Economic Commission for Europe**Administrative Committee for the TIR Convention, 1975****Technical Implementation Body****Eighth session**

eTIR conceptual, functional and technical specifications:**Version 4.4:****Concrete amendment proposals****New proposals****Concrete and new amendment proposals****Note by the secretariat****I. Background and mandate**

Figure I
Outline of declaration and operation eTIR message data flow

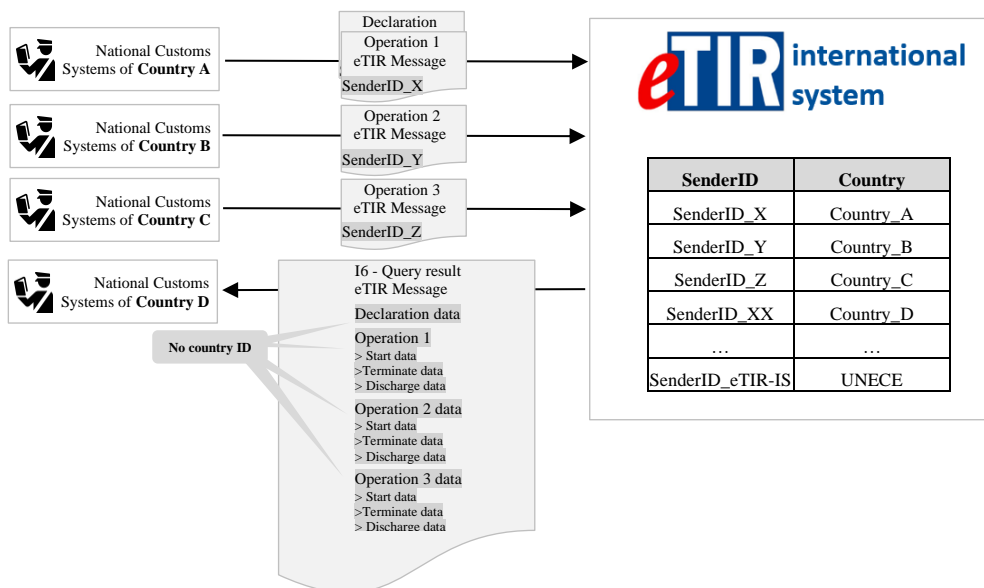
46. While developing the eTIR National Application, the secretariat noticed that the list of declarations, declaration amendments and operations contained in the E6 - Query result, I6 - Query result and I15 - Notify customs eTIR messages, the country of declaration/amendments/operations was not mentioned. This is due to the fact that eTIR international system composes the data of those messages, by copying “as is” the declaration/operation data received from customs in messages “I7 – Record declaration”, “I9 - Start TIR operation”, “I11 - Terminate TIR operation”, “I13 - Discharge TIR operation” and “I17 - Refusal to start TIR operation” without altering them, as described in the figure below (note: the country of the operation start, termination and discharge may not always be the same in customs unions).

47. As illustrated in the figure I, all eTIR messages contains data accompanied by a “Sender ID” and is signed by a X.509 certificate both identifying the country (national customs systems) it comes from. Based on this set of information, the eTIR international system (eTIR IS) has the capacity, using its truststore data, to authenticate the message sender and to deduce the country. Therefore, eTIR IS can also clearly identify the country of origin for each declaration/operation message even if those ones do not contain explicitly the related country code. However, when the international organization or national customs systems query about a TIR transport or when they receive a notification from the eTIR IS, the list of declarations/operations are sent “as received” without indicator of the country it took place in. Though, in general, the country can be deduced from the itinerary of the declaration, when a fallback procedure has been used, the information in the messages will not be sufficient to calculate the country involved without risk of error.

48. In order to calculate the countries of the declaration/operations in E6 - Query result, I6 - Query result and I15 - Notify customs eTIR messages, the secretariat first considered using the customs office IDs mentioned in the declaration/operations messages in order to find the related country of the office, and by deduction of the declaration/operation. However, it was found that due to the lack of harmonized format of customs office codes used by the customs authorities of the Contracting Parties to the TIR Convention, to the fact that most do not follow the current WCO recommended standard (UNLOCODE+8 digit national ID), using the customs office ID as currently recorded in the ITDB was not a reliable way to calculate the country of the declaration/operation.

Figure II
Outline of the proposed declaration and operation eTIR message data flow

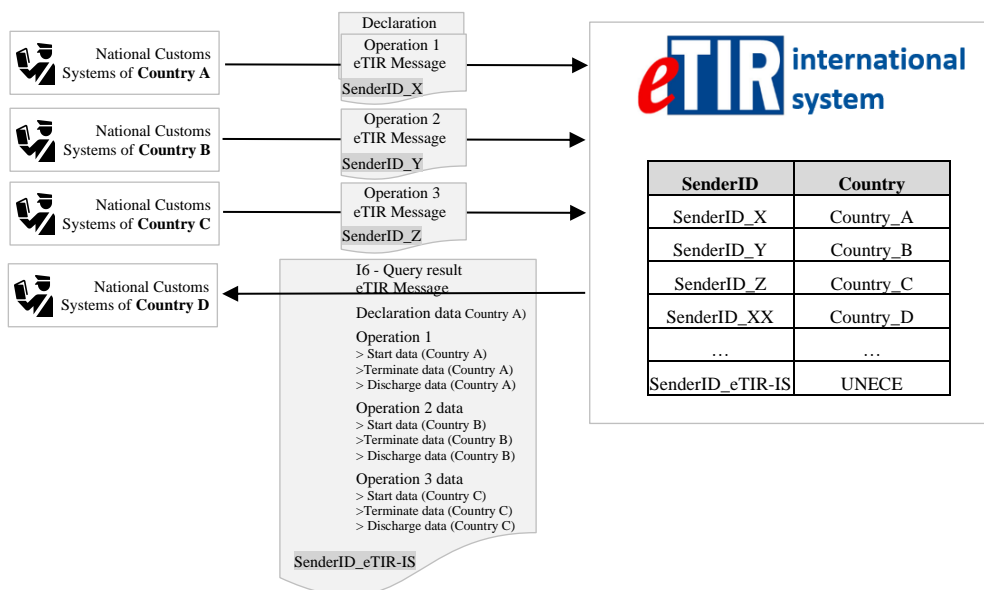
51. In the meantime, as the TIR secretariat had more time to reflect on the matter and on the original issue (having the country of declaration/operations listed in the E6 - Query result, I6 - Query result and I15 - Notify customs eTIR messages available to the message receivers). On one hand, the secretariat found out that the 2 options initially proposed do not addressed completely the original issue as no customs office ID is provided in the “I7 – Record declaration data” eTIR message. Consequently, those options would not allow to identify the country recording the declaration. On the other hand, the secretariat identified a new option addressing completely the original issue, and assessed it as less impacting for the eTIR stakeholders and for their systems (national customs systems, eTIR I.S., ITDB, ...). This new option is also affecting less the customs office data providers (the customs administration staff). This third option consists in adding the country code to each of the declaration and operation data blocks mentioned in the E6, I6 and I15 eTIR messages based on the Truststore/Sender ID information recorded the eTIR international system. This new option is illustrated in the simplified figure below:

52. This option would only impact the three eTIR message: E6 - Query result, I6 - Query result and I15 - Notify customs, would not impact ITDB nor the customs administrative users and does not depend on the harmonization of the customs office ID formats. It should be noted that this new option addresses the original issue of lack of country information in the declaration/operation eTIR messages, but it does not address the more global problematic of the unicity of customs office ID format that came up while looking for a solution to the original issue.
